## AGENDA

### Planning Commission

RE: Benderson Development Company, LLC  
Colonel Howard Boulevard/US Route 222  
Subdivision/Land Development Sketch Plan  
**Review No. 1**  
RETTEW Project No. 031722000

Benderson Development Company, LLC  
Subdivision & Land Development Plan  
Colonel Howard Boulevard/Route 222  
Sketch Plan - Zoning Review  
Prepared by: Wilkinson Apex Engineering Group, LLC  
Prepared for: Benderson Development Company, LLC  
Plan No. 2022-273  
Plan Date: January 6, 2023  
TEI File: 4035-125-BG13

**SKETCH PLAN**

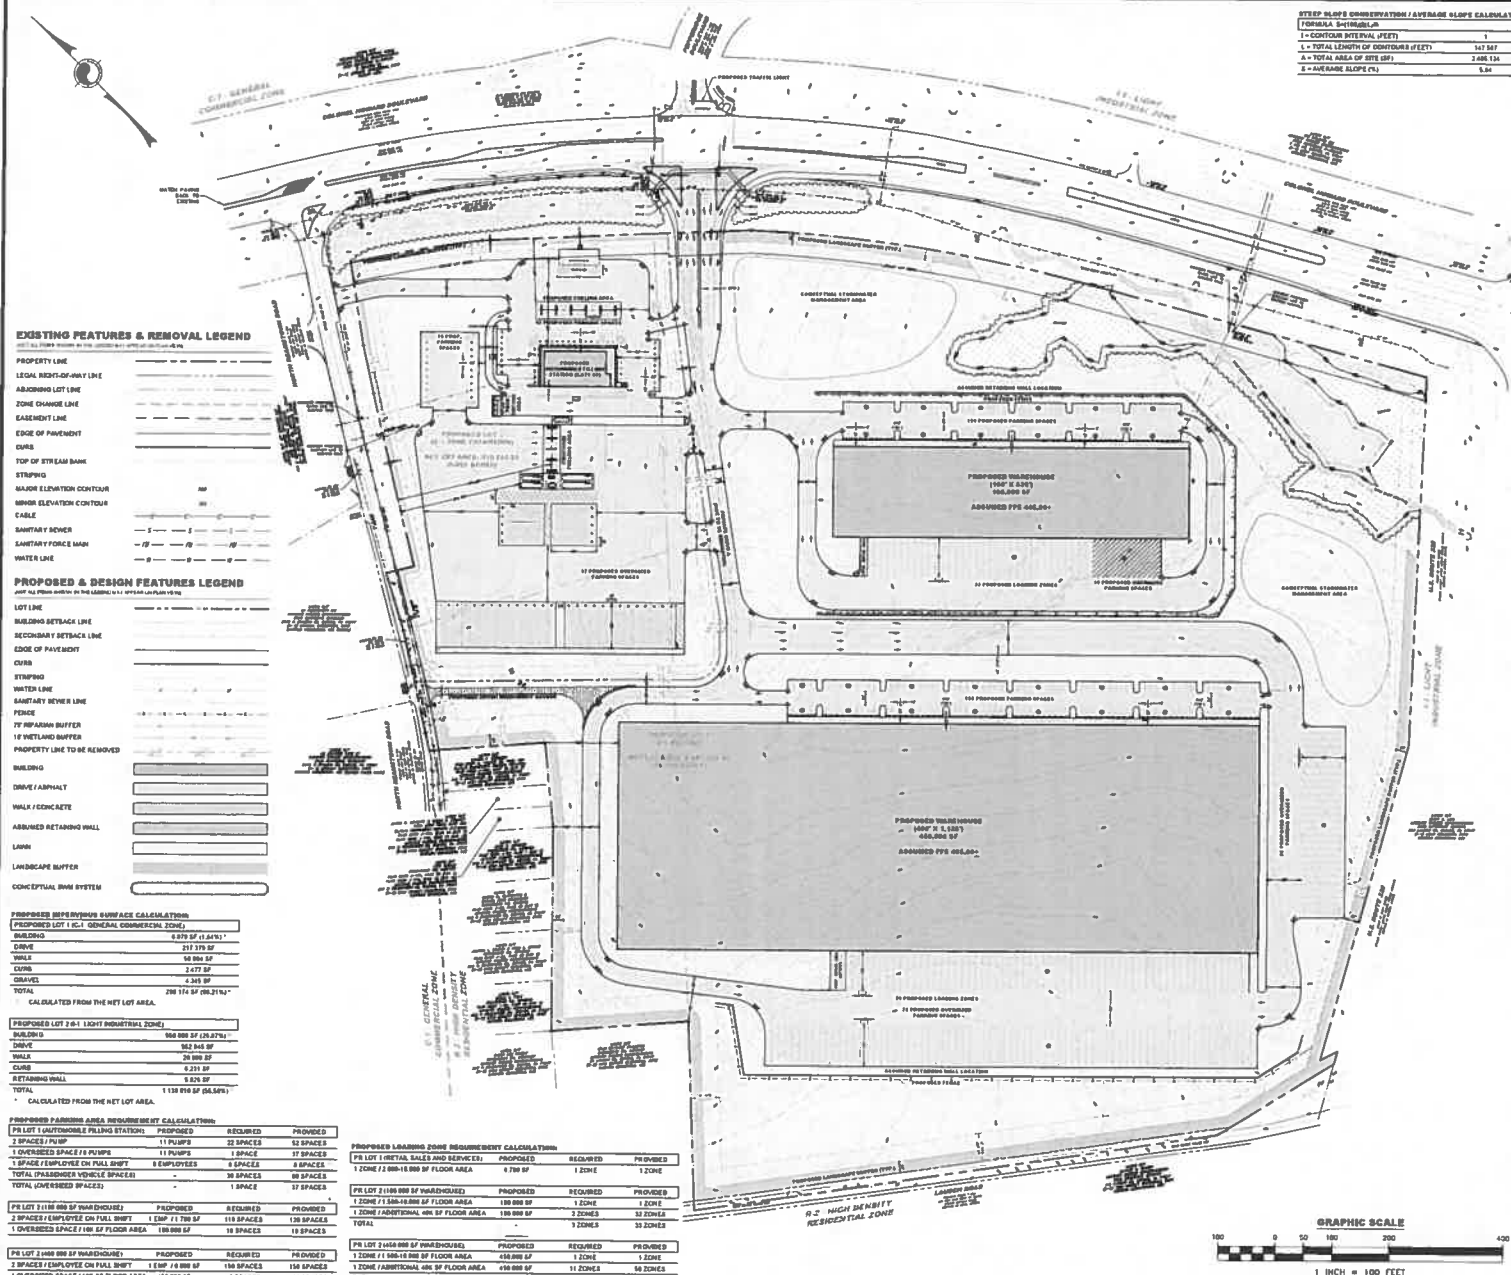
1. Stormwater management data and plans, designed in accordance with Chapter 185 of the East Cocalico Township Stormwater Management and Earth Disturbance Ordinance, need to be provided.

2. Stormwater runoff from a development site to an adjacent property shall flow directly into a natural watercourse, into an existing storm sewer system, or onto adjacent properties in a manner similar to the runoff characteristics of the predevelopment flow (§185.-22.E).

3. Proposed landscaping and lighting need to be indicated on the plans (§194-13.C.3).
  4. Provide a statement on the plan to indicate types of sanitary sewage disposal and water supply including the name of the authority (if applicable) (§194-13.C.4). The applicant needs to coordinate directly with the Authority.

5. A traffic impact report is required at Preliminary Plan submittal (§194-14.E.4).
  6. The applicant will need to satisfy the park and recreation dedication requirements (§194-14.E.5, 194-46.B.2).

7. A wetland study is required at Preliminary Plan submittal (§194-14.E.7).
  8. The Township needs to determine if a fiscal impact analysis is required (§194-14.E.11).
-

9. Improvements to existing streets are required when a subdivision and/or land development abuts a Township street and/or state route and does not conform to the right-of-way or improvement standards (§194-25.C.1). The minimum street rights-of-way shall be 60' and the minimum cartway width shall be 36'.

10. Sidewalks shall be provided along all street frontages (§194-32).
11. Curbs and/or shoulders shall be provided along all streets (§194-33).
12. The proposed access drive intersection with North Reamstown Road needs to be across from the existing access on the opposite side of the street (§194-28.D.5).

13. The applicant needs to clarify the utility and screening easements noted to be removed.
14. The applicant indicates proposed buildings and paving over the existing unnamed tributary and existing wetlands. Evidence of approval from PADEP will need to be provided.

15. Signed and sealed design calculations and details for the retaining walls will need to be provided and be included in the cost estimate for financial security.

16. PennDOT utility permits are required for sanitary sewer and water connections in Colonel Howard Boulevard (S.R 1040). In addition, the location of the existing gas line needs to be verified per General Note #12 on sheet 1.

17. PennDOT Traffic Impact Study (TIS), Highway Occupancy Permit (HOP), and Traffic Signal permitting approvals are required. Continued review of all reports and documents will define the traffic impacts and necessary improvements of the project. The following comments are based on the review of the sketch plan:

- a) The applicant needs to review the entering and exiting lane assignments of the access drive at Colonel Howard Boulevard. The TIS needs to determine the number and classification of each lane.

- b) The cartway width of the access drives for two lanes of traffic is 24' (§197-28.H). In addition, the access drives for the proposed automobile filling station/proposed fueling area/proposed 100,000 SF warehouse, along Private Drive A, need to align. Lastly, the grass strip radius between the proposed automobile filling station and the proposed fueling area needs to align with the north cartway edge of Private Drive A.

- c) Turning templates need to be provided for the largest vehicle anticipated to access the site to demonstrate adequate access and circulation for the proposed uses.

- d) Provide pedestrian walkways from the signal at Colonel Howard Boulevard into the site and to the proposed automobile filling station. In addition, the applicant needs to provide internal walkways from the proposed warehouses to the proposed automobile filling station, from the 18-space parking lot to the proposed automobile filling station, and from the proposed fueling area to the proposed automobile filling station.

- e) We recommend that the northern access drive at the proposed 450,000 SF warehouse be eliminated to keep truck traffic away from the existing properties along the boundary. In addition, truck traffic needs to be separated from the vehicular parking lots.

- f) The applicant needs to clarify the four lanes for truck traffic between the proposed warehouses.
  - g) We recommend that a parking restriction be established along all property frontages.

- h) Investigate the potential of a Park-N-Ride lot on the site.
18. A transportation impact fee is required (§203-5). The impact fee needs to be calculated based on the ITE PM peak hour trips for each proposed land use. No deductions for pass-by and/or diverted link trips will be permitted.

1. It should be noted that the applicant is proposing to consolidate and resubdivide the three parcels noted previously. In addition, the applicant is proposing to rezone the subject properties to meet their intent for the proposed uses on the newly created lots. The rezoning request must be approved by the Township and Zoning Hearing Board as part of the overall project.

2. The majority of proposed lot #1 is currently located within the C-1 zoning district with a small portion currently located in the R-2 zoning district. Assuming the rezoning request is approved to include all of proposed lot #1 in the C-1 zoning district, the proposed automobile fueling/filling station would be permitted by special exception via approval from the Zoning Hearing Board and provided it meets the requirements of §220-68. It should be noted that an automobile filling station is not listed as a permitted use in the current underlying R-2 zoning district. §220-21.C(2) & 68

3. The maximum height of the proposed structure on lot #1 is noted in the zoning information as being 50 feet. If the proposed structure exceeds 35 feet, the applicant shall be required to obtain a letter from the Fire Chief of the "primary call" fire company determining that the building has adequate fire suppression equipment and/or that adequate fire-fighting and rescue capabilities exist to serve such a structure. §220-21.G

4. Off-street loading shall be provided and no off-street loading area shall be permitted on any side of a building facing an adjoining street. It appears that the proposed off-street loading area is shown between the proposed filling station and Colonel Howard Boulevard. The applicant shall address this issue accordingly or request zoning relief from the section. §220-21.H

5. A minimum ten foot wide landscape strip shall be provided along all property lines. The landscape strip is indicated however no proposed landscape planting scheme is shown. The applicant will need to address this requirement as part of the land development process. §220-21.M & 44

6. There are proposed dumpsters shown on the plans, which appears to meet the setback requirement of the ordinance. All dumpsters shall be completely enclosed within a fenced or masonry enclosure and equipped with a self-latching door or gate. A detail for the enclosure for the dumpster should be included on the plans to address this requirement. §220-21.N

7. The majority of proposed lot #2 is currently located within the C-2 zoning district with a small portion currently located in the R-2 zoning district. Assuming the rezoning request is approved to include all of proposed lot #2 in the I-1 zoning district, the proposed warehouses would be permitted by right provided it meets the requirements of §220-126. It should be noted that the warehouse use is not listed as a permitted use in the current underlying R-2 or C-2 zoning districts. §220-23.B(27)

8. Any use adjoining land within a residential zone or across a road from land within a residential zone shall maintain a 50 foot setback and this area must be landscaped. The applicant is

showing the 50 foot required setback, however no proposed landscape planting scheme is shown. §220-23.H(4) & 44

9. The maximum height of the proposed structure on lot #2 is noted in the zoning information as being 75 feet. The maximum height of any proposed principal or accessory structure shall not exceed 50 feet except those uses listed in the ordinance under §220-34. A warehouse use is not listed in this section, therefore the maximum height of the structure shall be 50 feet. The applicant shall address this issue accordingly or request zoning relief from the section. §220-23.I

10. Off-street loading shall be provided and no off-street loading area shall be permitted on any side of a building facing adjoining lands within a residential zone nor on any side an adjoining street. It appears that the proposed off-street loading area is shown between the larger proposed warehouse and Lausch Road/Route 222 as well as the R-2 zoning district to the south, which does not comply with these sections. The applicant shall address this issue accordingly or request zoning relief from the section. §220-23.J & 43.C & 126.B(2)

11. A visual screen must be provided along any adjoining lands with an existing residence and/or within a residential zone. A minimum twenty foot wide landscape strip shall be provided along all property lines. The landscape strip is indicated however no proposed landscape planting scheme is shown. The applicant will need to address this requirement as part of the land development process. §220-23.N & O & 44

12. There are proposed dumpsters/refuse areas shown on the plans, which appears to meet the setback requirement of the ordinance. All dumpsters shall be completely enclosed within a fenced or masonry enclosure and equipped with a self-latching door or gate. A detail for the enclosure for the dumpster should be included on the plans to address this requirement. §220-23.P

13. The Township Historic and Riparian Buffer Overlay Zones Map indicates that there is an existing historic site located on the warehouse property (proposed lot #2). It appears that the existing farmhouse has been previously demolished at an unknown time and all that remains is a concrete pad, which is proposed to be removed as part of the overall project. Given the current state of the property, it would appear that no demolition permit is required. §220-28

14. The use of retaining walls higher than 10 feet are permitted in any yard up to a maximum height of 30 feet provided the information noted in the ordinance is provided. We are unable to determine the heights of the proposed retaining walls at this time given the information shown on the plans. The applicant shall provide all information related to this section to the Township for review. A note shall be added to the plans indicating that a building permit is required for all retaining walls higher than 4 feet in height and the wall plans must be signed and sealed by a registered professional engineer. §220-31.A(2)

15. A PADOT Highway Occupancy Permit is required for the proposed access driveway onto Colonel Howard Boulevard and meet all requirements of the SALDO. Turning templates should be provided for the largest vehicle anticipated to access the property to demonstrate adequate access and circulation for the proposed uses. §220-39 & 41

16. It appears that the applicant is providing the minimum number of required parking spaces, oversized spaces and loading/unloading spaces as required by the ordinance for the proposed uses. §220-42 & 43

17. There is a note on the cover sheet indicating that a qualified expert will testify that the proposed uses will comply with the requirements of the noise ordinance except as specified. We would recommend that this issue is addressed as part of the overall rezoning approval from the Zoning Hearing Board. §220-48.A & 126.B(3)

18. The applicant shall indicate whether there will be any proposed lighting with the project. If lighting is proposed, an illumination plan shall be provided for review and comment. Additional lighting details must be included and demonstrate compliance with the shielding and height requirements. In addition, the applicant shall submit qualified expert evidence that the proposed use complies with this section. We would recommend a plan note on the record cover sheet is provided indicating that building permits are required for all proposed lighting and shall comply with the requirements of this section of the zoning ordinance. §220-48.B & 126.B(5)

19. The plan will be reviewed by the Township Building Code Official for accessibility to the proposed structures and comments provided as part of the land development review. §220-48.F

20. A note should be provided on the plans addressing the requirements for materials and waste handling. Additional information should be provided to the Township related to the proposed uses in conformance with this requirement. §220-55

21. In the C-1 Zone, the subject property for an automobile filling station shall be setback at least 300 feet from any lot containing a school, day care, playground, library, hospital or nursing, rest or retirement home. It appears that proposed lot #1 will be located within 300 feet of an existing senior living home and would require a variance from this requirement. §220-68.C

22. In the I-1 zoning district, warehousing is permitted by right subject to the criteria listed in this section. The applicant shall provide a detailed description of each proposed use in accordance with this section and prepare a traffic impact report. §220-126.A

23. The subject property shall be located no closer than 500 feet from any R-2 zoning district and/or property containing a school, day care, park, playground, library, hospital, nursing, rest of retirement home or medical residential campus unless all of the requirement noted in this section are addressed. The proposed lot #2 is located within 500 feet of the R-2 zoning district boundary and as noted previously, the proposal does not meet the loading area location requirements of the ordinance. In addition to our previous comments, the noise attenuation barrier requirement must also be met for the proposal given its proximity to the R-2 zoning district. The surfacing for the proposed use must be designed and constructed to the local street standards of the SALDO. §220-126.B

1. The plan indicates that there are existing wetlands and an unnamed tributary on the property proposed to be removed. PADEP permitting may be required to accomplish this removal of wetlands and the tributary from the property.
2. The applicant must comply with all other applicable requirements as part of the Township's SALDO and traffic review as well as comply with all other outside agency requirements as necessary.
